UNITED STATES PATENT AND TRADEMARK OFFICE

10/518,633

Office Action Summary	Application No. 10/518,633	Applicant(s) ARMER ET AL.	
	Examiner DNYANESH KASTURE	Art Unit 3746

DETAILED ACTION

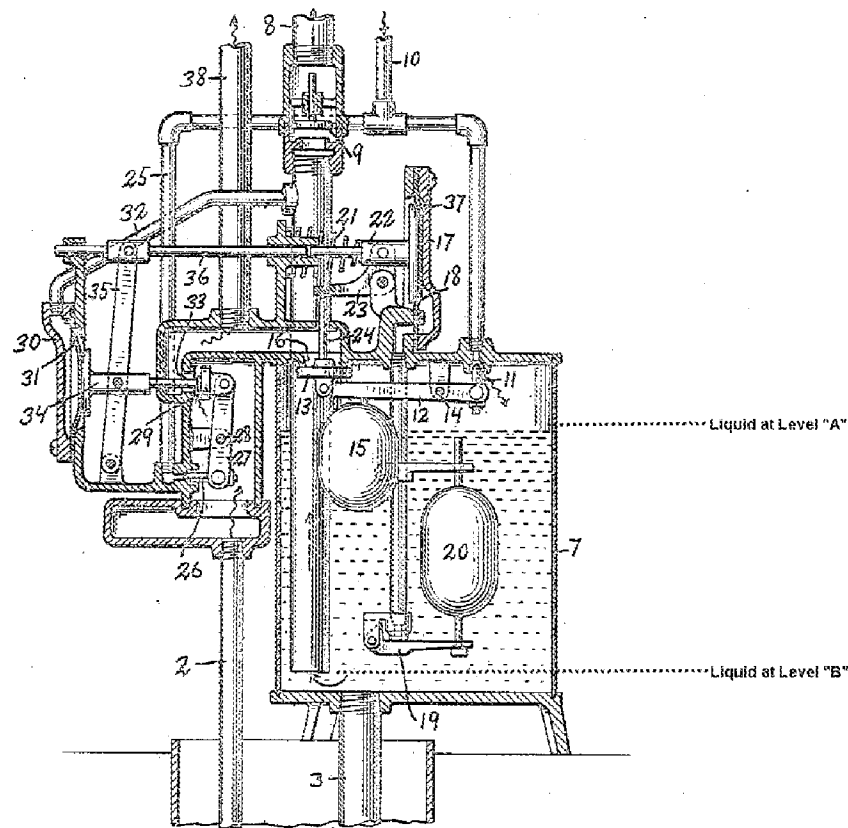
9. In Re claim 1, with reference to blow up of Figure 1 depicted above, Rogers discloses a pump apparatus (title) including:

- a first container including a chamber (4), an inlet (5) and an outlet (6), the chamber being pressurisable (compressed gas entering through tube 2) to effect discharge through the outlet;
- a control apparatus (Fluid motors 17 and 30) for causing periodic pressurisation and depressurisation of the chamber as part of a pressurization/depressurization cycle in response to the level of liquid in the container (once the chamber is full of liquid, the pressurization cycle occurs, therefore it occurs in response to the level of liquid in the chamber),
- wherein the control apparatus includes a pilot valve (11) located in a second

container (7), the second container being connected to, and receiving liquid from, the first container through pipe (3) when the level of liquid in the first container rises to a first predetermined level (which is the level at which the first chamber is full),

- the pilot valve (11) being configured to open when the liquid level in a second chamber (inside 7) is sufficiently high; as evident from Page 2, Lines 25-33: "The drawing shows the parts in the positions which they occupy when the water in the pump chamber 7 is being discharged by the pressure of compressed air . . . with the compressed air valve open". When the liquid level is at "A" as annotated, the liquid level is "sufficiently high" to push the float (15) against the rocking lever (12) thereby opening valve (11)

- with regard to the claim limitation "to trigger a pressurisation/depressurisation cycle of the chamber of the first container", when the water level in chamber (7) reaches Level "B" as annotated, the system is configured "to trigger a pressurisation cycle" of the chamber of the first container (4). It is noted that there is a time delay between the opening of valve (11) and triggering pressurization of chamber (4) because the pressurization of chamber (4) does not occur until the liquid level has dropped from Level "A" to Level "B", however the examiner points out that the applicant's invention ALSO has a time delay between opening of the pilot valve and pressurization of the first chamber, because the pressure in line 326 of applicant's Figure 3 has to drop sufficiently to overcome the inertia of shuttle valve element 340 so it moves to the right (another time delay occurs to complete the motion of the shuttle valve sufficiently to the right) allowing the compressed air passage to communicate with the first chamber. The

definition of "triggering" in the spirit of applicant's invention therefore can include a time delay.

- and to close (valve 11) in response to the liquid level in the second container (7) falling below a second predetermined level "B", which triggers depressurization,

- the state of the pilot valve determining pressure within a portion (16) of the apparatus, and
- a shuttle valve (32, 34, 22, 23, 36) configured to change state directly in response to the pressure within the portion of the apparatus (when the chamber 7 is allowed to exhaust through 16, the rod 26 moves to a position where pressurization of the first chamber 4 occurs),

- the state of the shuttle valve determining whether motive gas enters into, or is vented from, the first container (when the rod 36 of the shuttle valve moves to the left, motive gas enters chamber 4, and when the rod 36 of the shuttle valve moves to the right, motive gas is cut off by 27 and the chamber 4 is allowed to vent) thereby implementing the pressurisation/depressurisation cycle.

11. In Re claim 10, Rogers discloses "high level" annotated as level "A" and a "low level" annotated as level "B". The apparatus being arranged so that when one chamber (4) is discharging fluid, the chamber (7) is receiving fluid (from chamber 4).
